Agenda Item #6 Application 2024-58-CA

301 McDonald Avenue

Replace 4 windows on north elevation with vinyl windows not matching the originals in dimensions or light configuration.

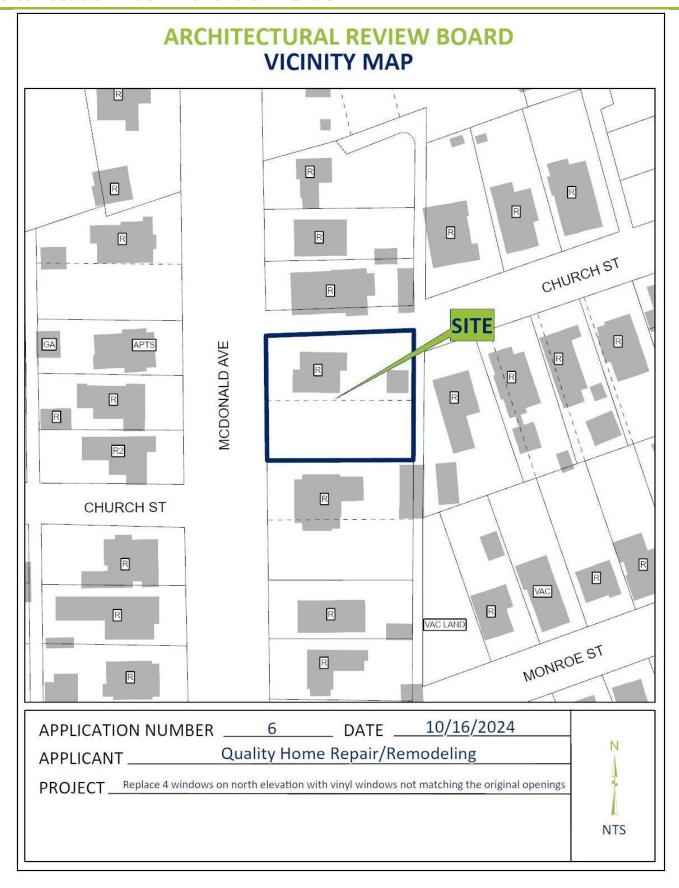
The two sets of windows proposed for replacement are slightly different in light pattern and size. The existing windows have a six-over-one light pattern, whereas the proposed replacements are four-over-one. The existing easternmost windows measure 30" wide by 40" high. The proposed replacement windows would be 4" shorter and 6" narrower. The windows would maintain the existing lintel height with shortening on the bottom. The westernmost pair of windows are 24" wide and 40" high; the replacement windows would be of identical width but 4" shorter. The lintel height also would be retained here, with the shortening on the bottom. In order for the new windows to blend into the elevation, the entire north elevation would be resided in kind.

The *Guidelines* instruct that historic materials should be removed and replaced only when they are beyond reasonable repair, which has not been shown to be the circumstance in this case. (5.4) The the *Guidelines* do not specifically address the presented circumstance, a proposal to replace the existing windows with shorter windows to accommodate new cabinetry and counters in a kitchen renovation. However, the *Guidelines* clearly state that when replacement windows are proposed, "the new windows shall match the existing as per location, framing, and light configuration." (5.21) The proposed replacement windows would be in the same location, but they would not match the existing in light configuration. Furthermore, vinyl is considered an unacceptable window material for contributing properties within Mobile's historic districts. (5.22)
